APPLICANT: 825 Mars Hill LLC

PETITION NO.: Z-66

PETITION FOR: R-20/OSC

ZONING COMMENTS:

Z-66

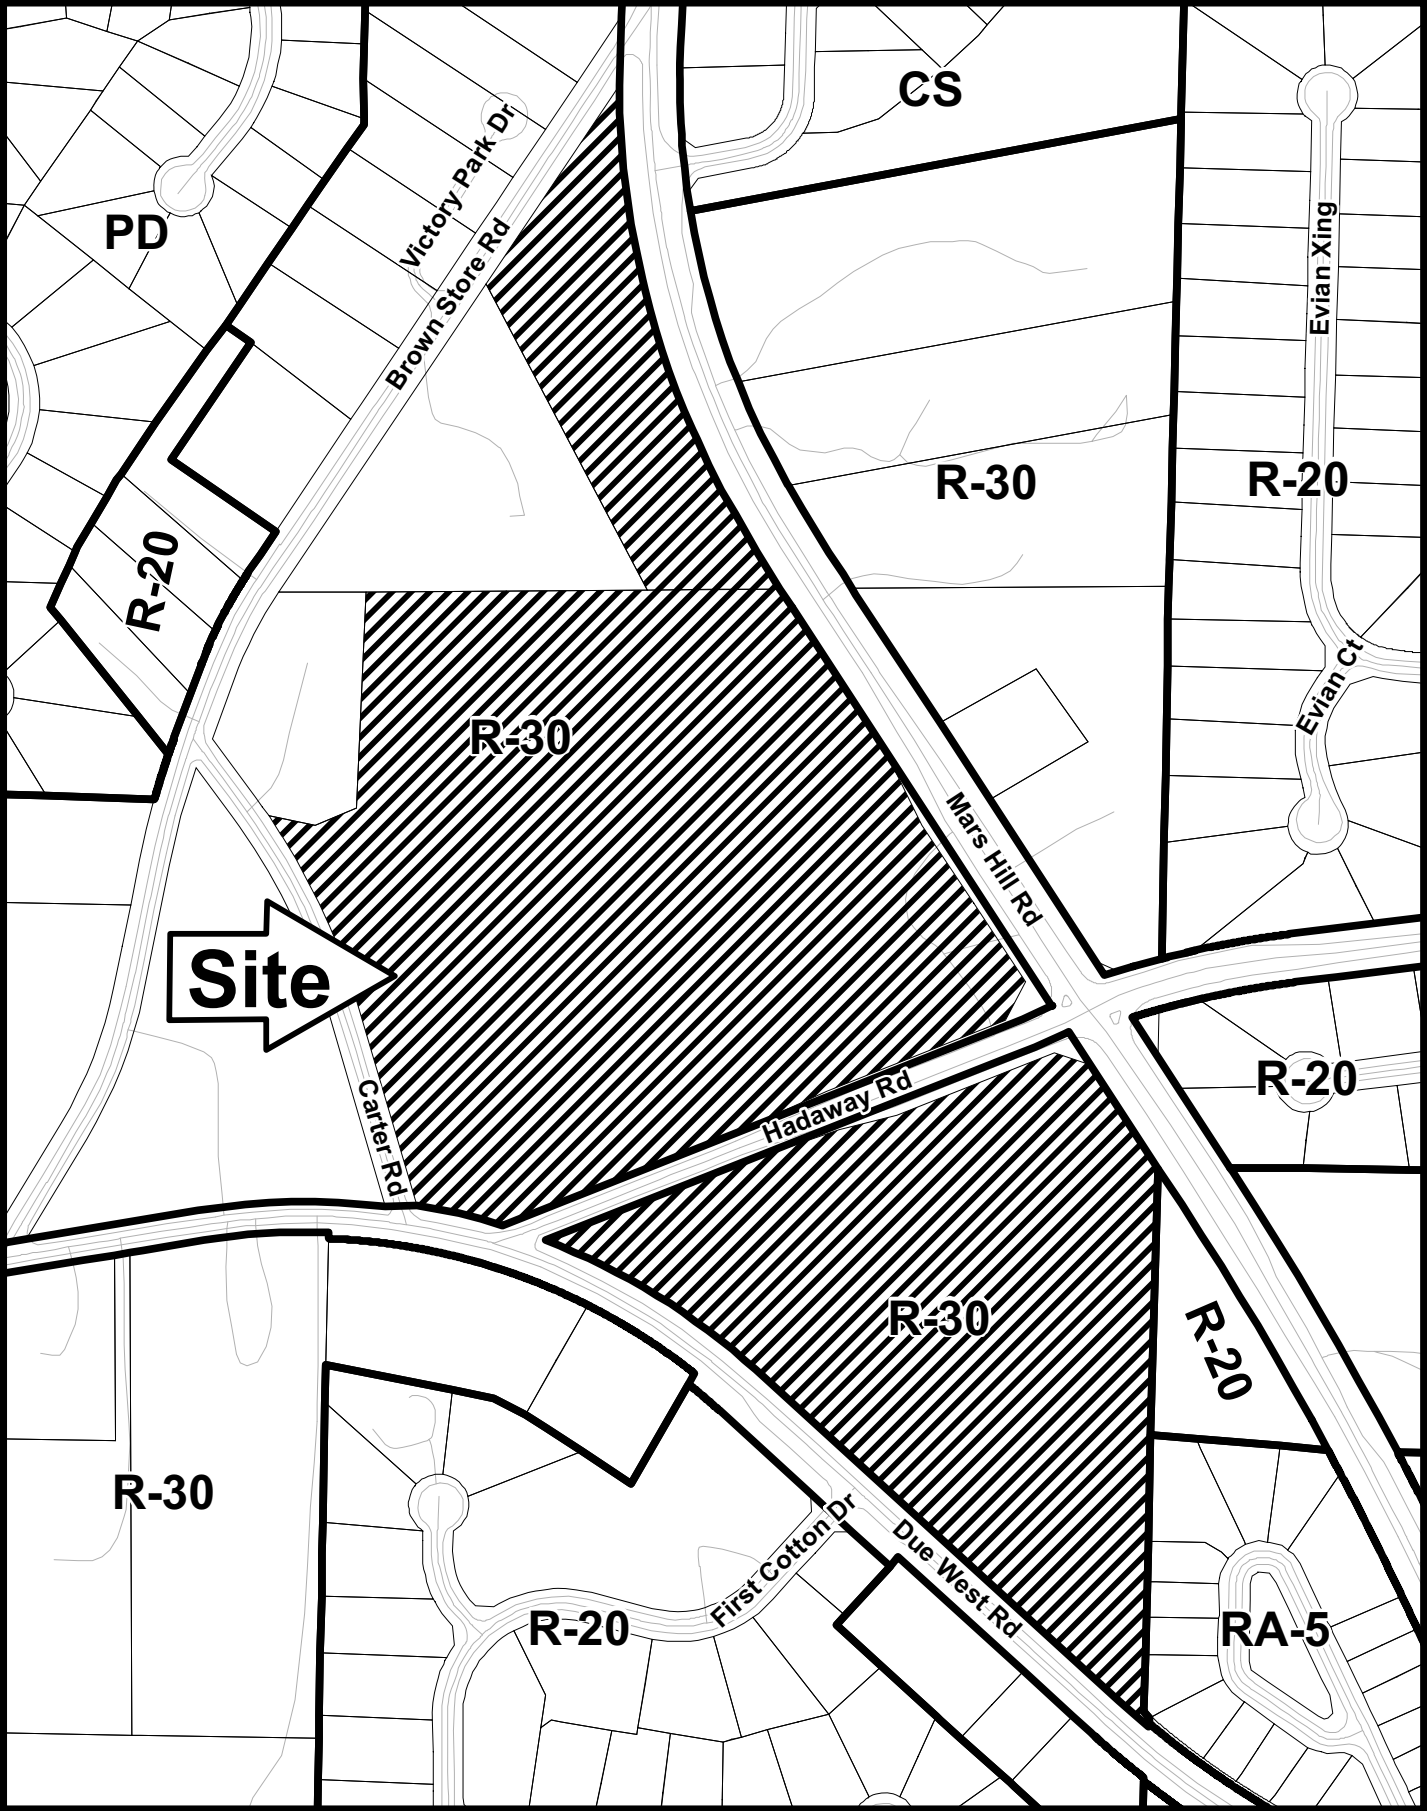
1. Site Plan stamped received on May 7, 2015 does not currently meet the requirements for R-20 Open Space Community, which requires 35% open space. The submitted plan provides 11.21 acres. Required open space for this plan would need to be 12.35 acres.

2. Lots 1 through 4 and a portion of 5 are located within the 25' state stream buffer and the 50' county stream buffer. All stream buffers must be within the open space.

3. Open space shall be designed to provide connection to adjacent property when the adjacent property is currently undeveloped or consists of established open space or conservation area. Contiguity of open space is highly desirable. Need to design connection of open space between the tract on the north side of Hadaway Road and the tract on the south side of Hadaway Road.
